Perlim - 51 W. Lenox St - 35/13
Chevy Chase Historic District

HISTORIC PRESERVATION COMMISSION STAFF REPORT

Address:	51 West Lenox, Chevy Chase	Meeting Date:	08/17/05
Resource:	Non-Contributing Resource Chevy Chase Village Historic District	Report Date:	08/10/05
Review:	Preliminary Consultation #2	Public Notice:	08/03/05
Applicant:	Mr. and Mrs. Hartman (Thomas Manion, Architect)	Tax Credit:	None
		Staff:	Michele Oaks

Proposal: Major additions to a non-contributing resource

SECOND FLOOR PLAN

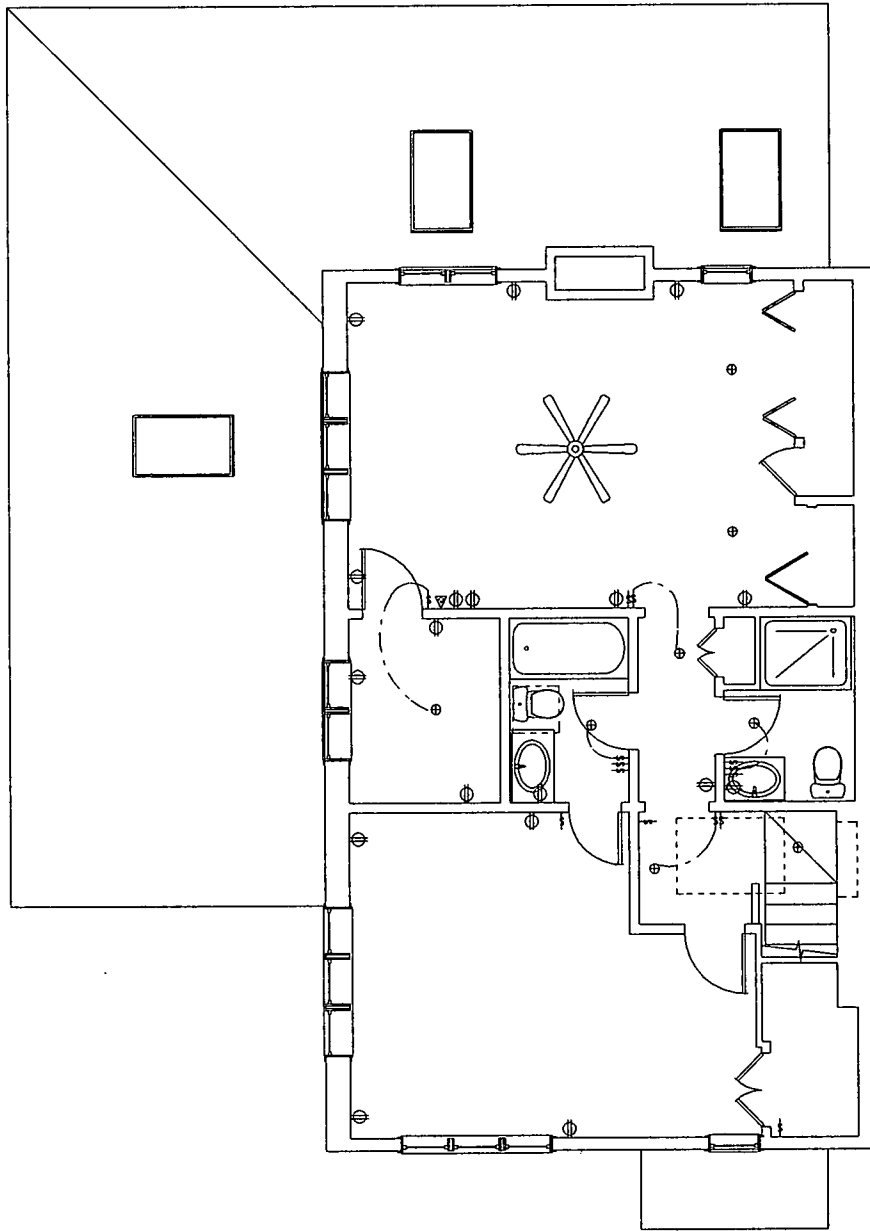
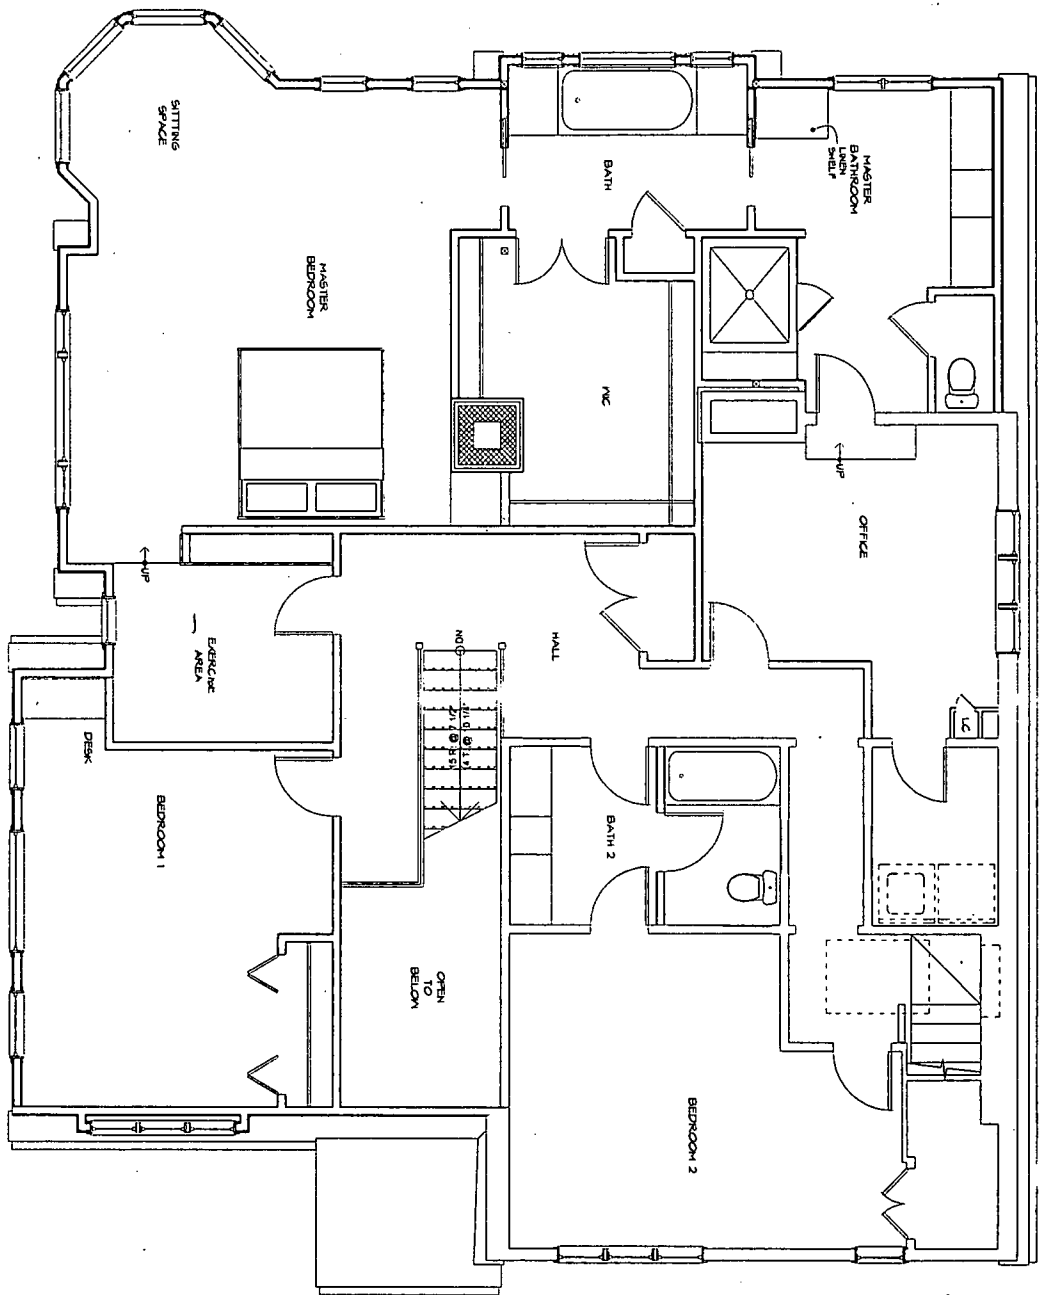
However, staff has looked at the proposed plans and notes that on the second floor, the shed roof, frame addition created for the walk-in closet is not compatible with the exterior façade of the building. It is currently covering the stone chimney, which is a prominent detail on this façade. It is staff's suggestion that this shed roof addition be eliminated and the interior space re-worked. The added benefit of the elimination of this shed extension is that it will also provide more visibility for the adjacent neighbor.

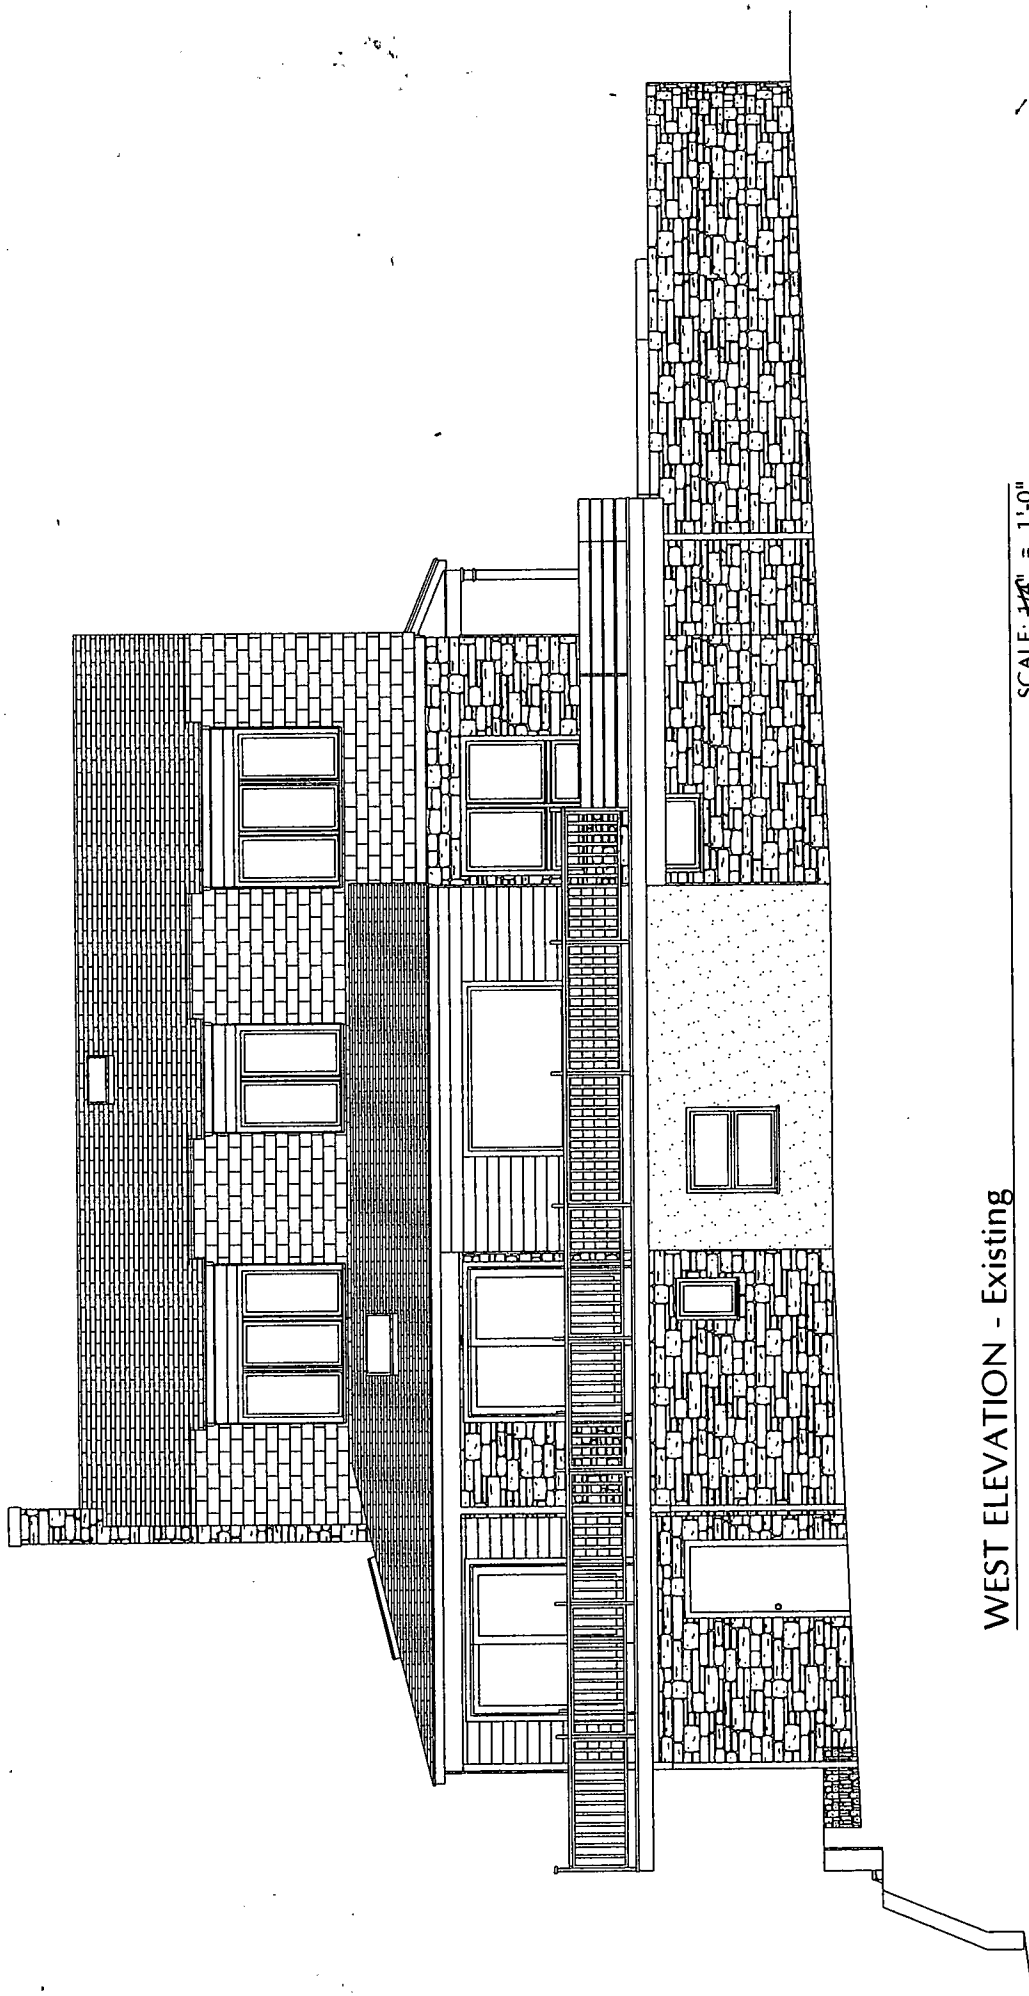
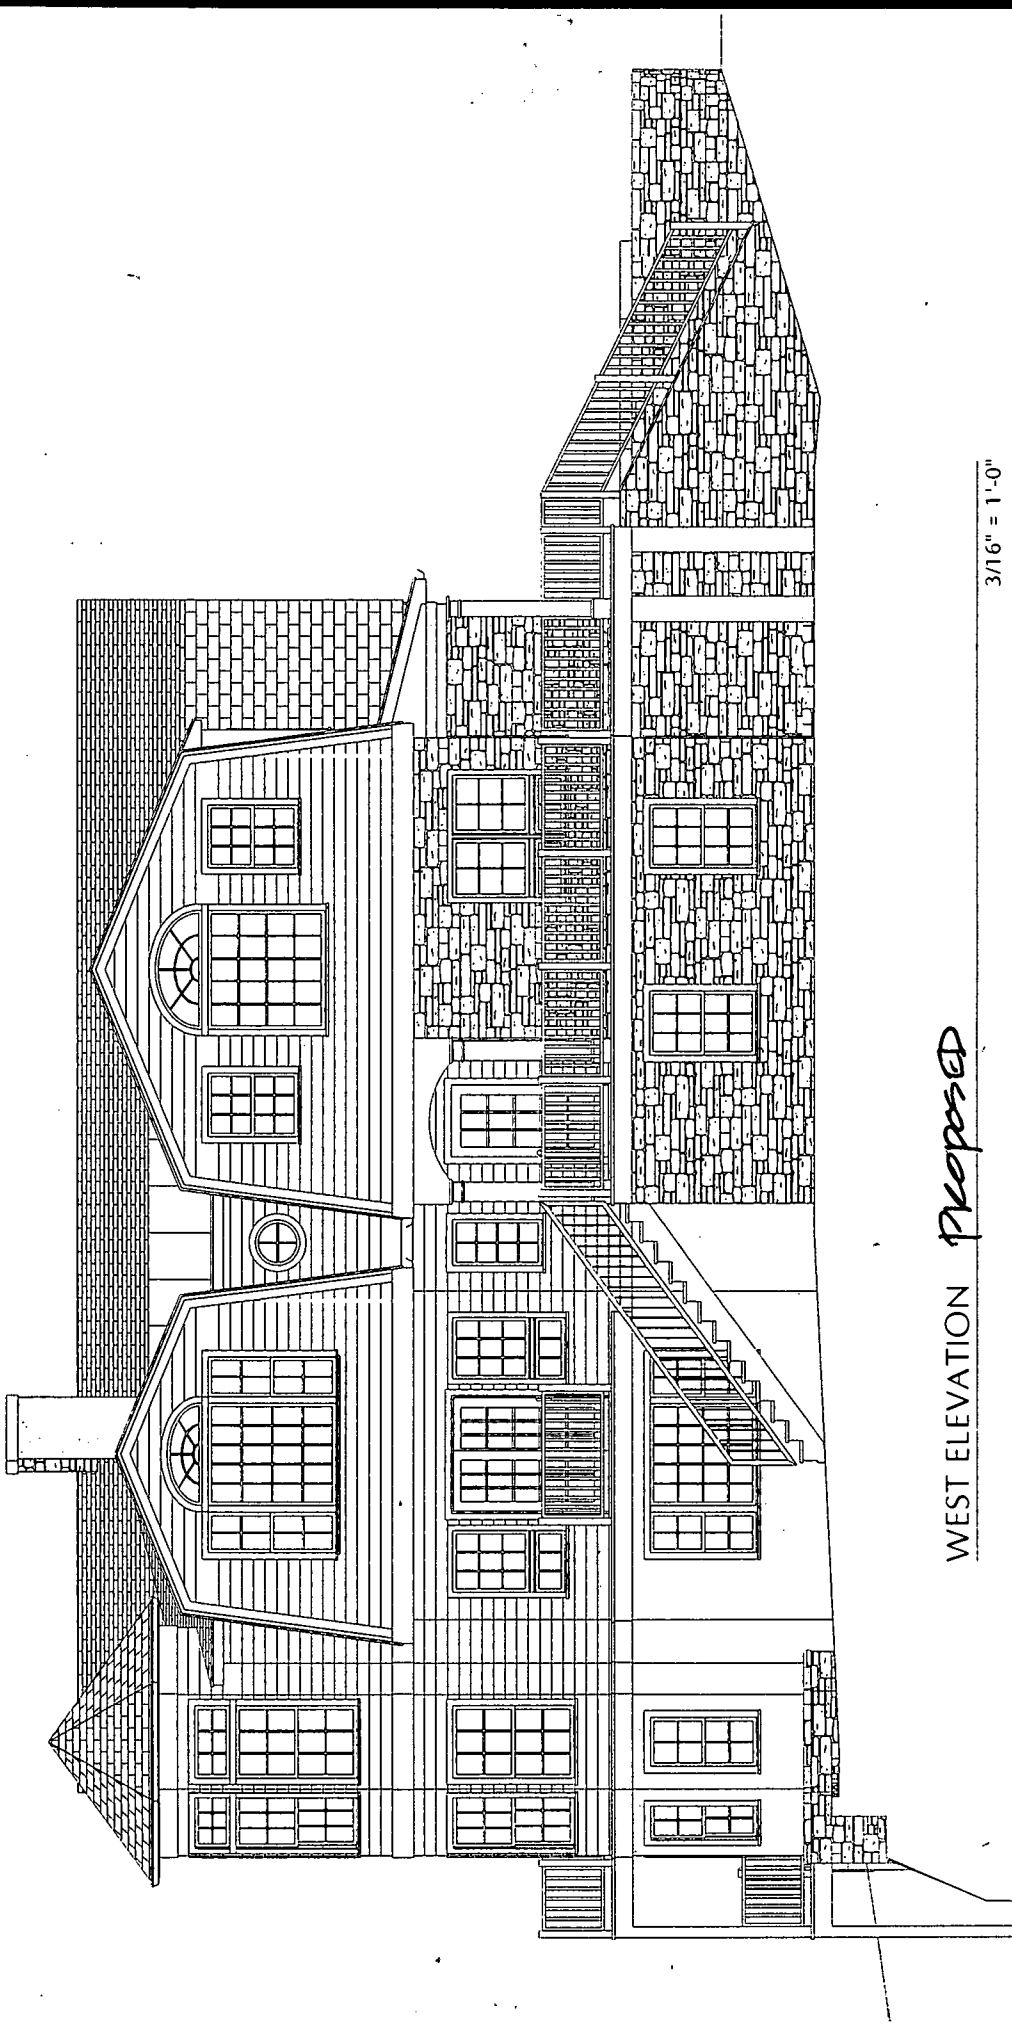
2 On sheet 16 and 17 you can see the existing side
3 porch towards the golf course. And what we've done on both
4 this and the rear is try to use sort of the Dutch gambrel
5 image all the way around the house and we have built over
6 the top of the one-story room again and come out with a
7 Dutch gambrel -- has the semi-circle windows at the top.
8 And behind that is -- again, we built over that one-story
9 porch and closed the porch and the tower in the corner.

REAR
NORTH ELEVATION - Proposed

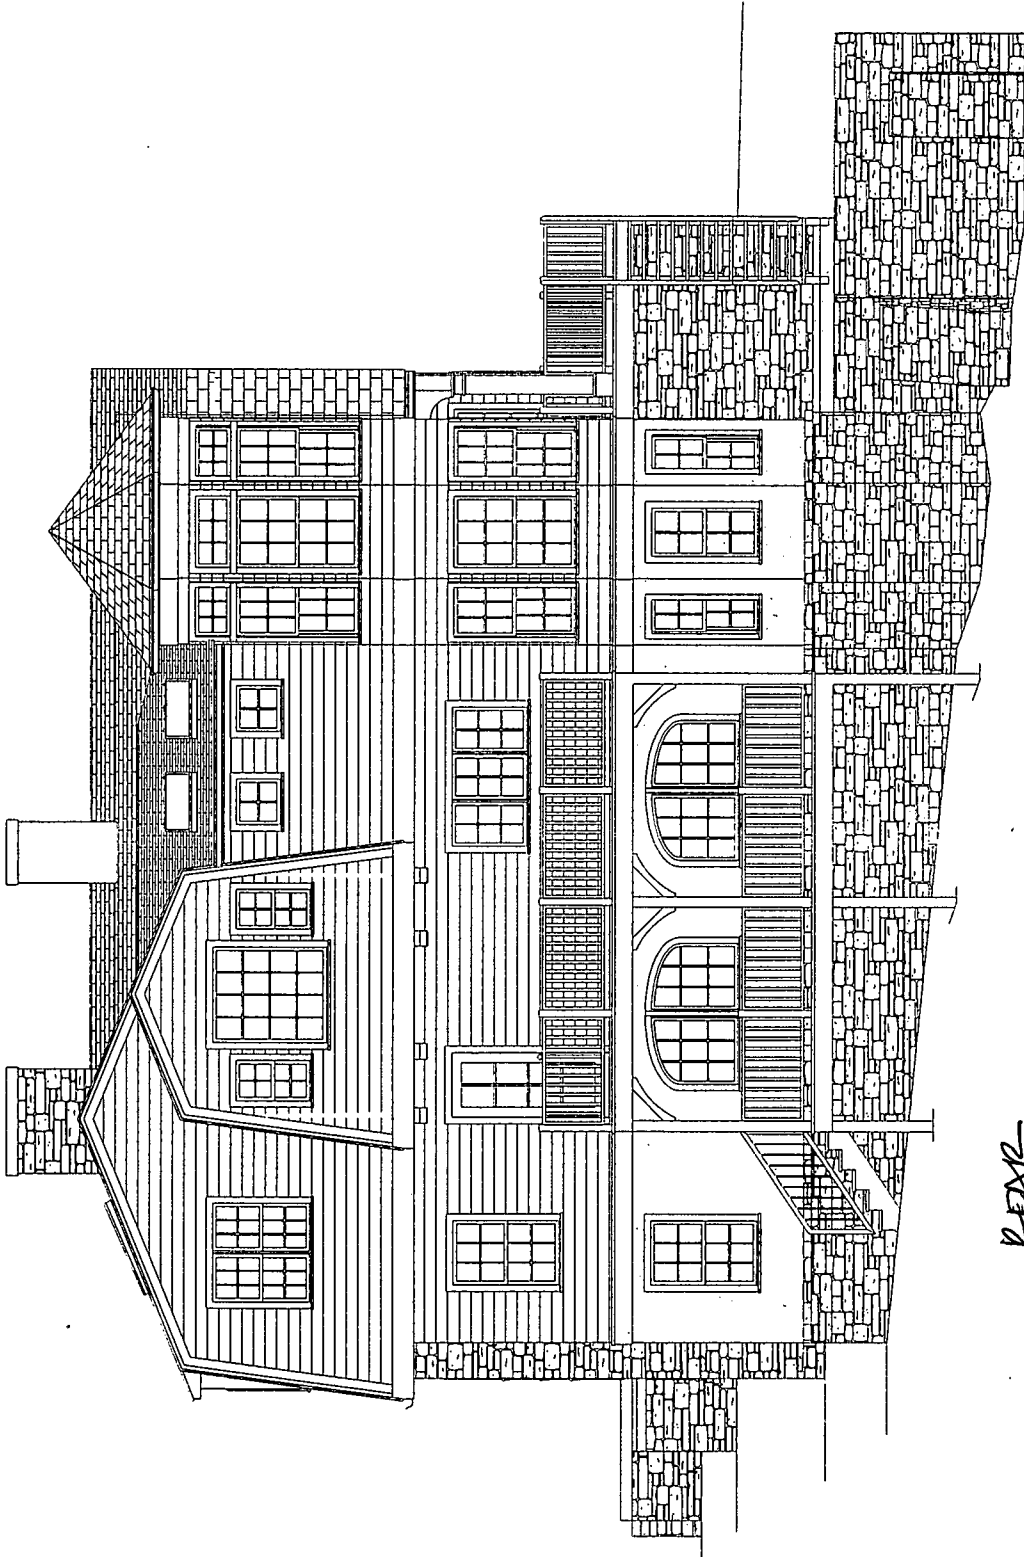
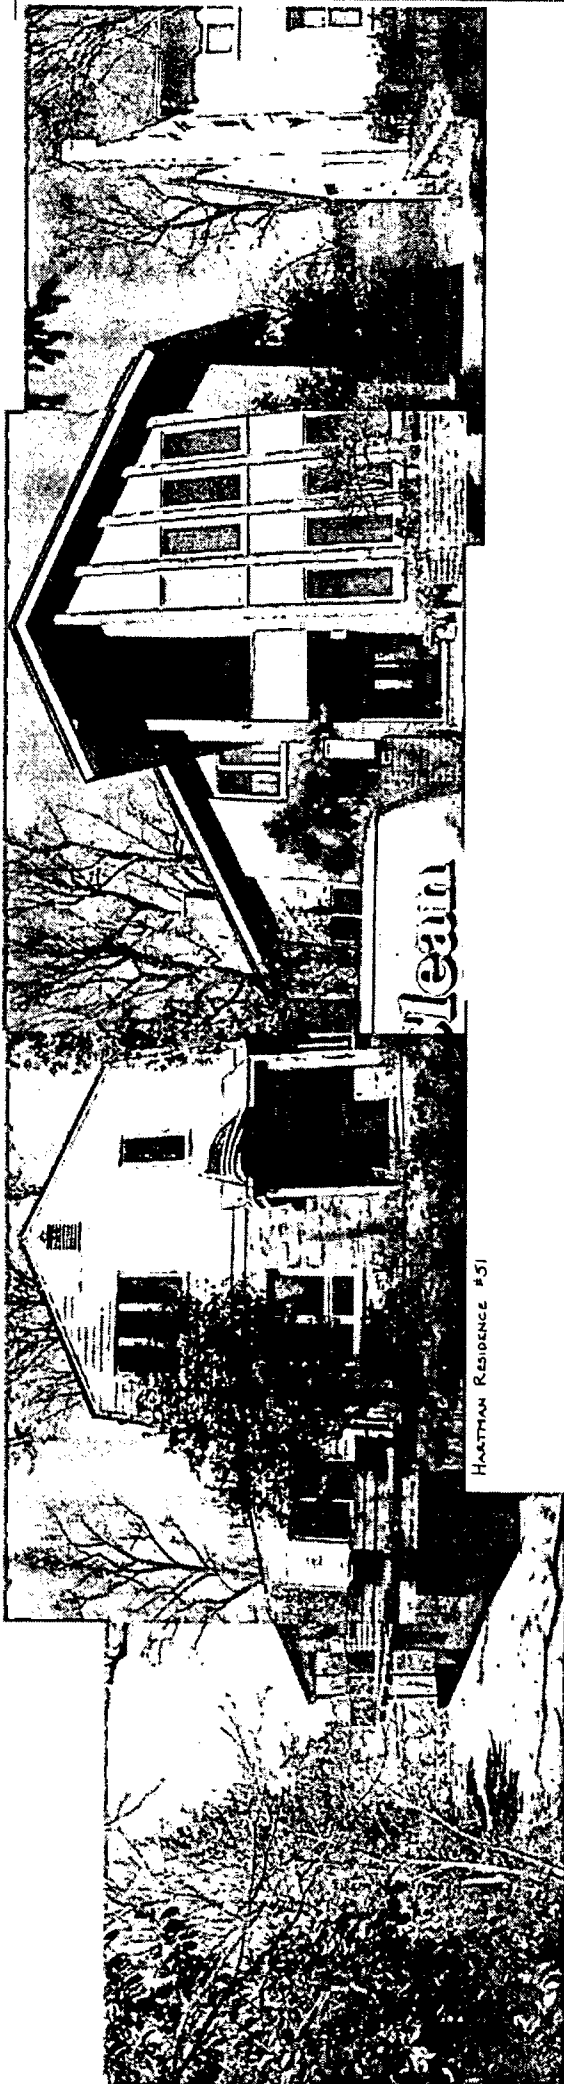
14 Our concern is principally with the expansion on
15 the north side, which is actually away from the street, but
16 it's in a sense the front of our house; the north side
17 overlooking the golf course. And we feel, as I said before,
18 that the extension of the house in that direction which so
19 vitally affects the feel and the light and the setting of
20 our house as opposed to expanding the house on the west,
21 which really affects nobody. That would be the area that we
22 would -- we're hoping to meet with their architect and see
23 if we couldn't modify their plans along those lines.

1 scale this is drawn about a half of an inch from the -- of
2 the drawing there. There's the current end of the house. I
3 think at a minimum we would like to see basically that that
4 be the proposed northern limit of the house as well. That
5 will protect the trees and that the balance of this square
6 footage somehow be shifted toward the west.
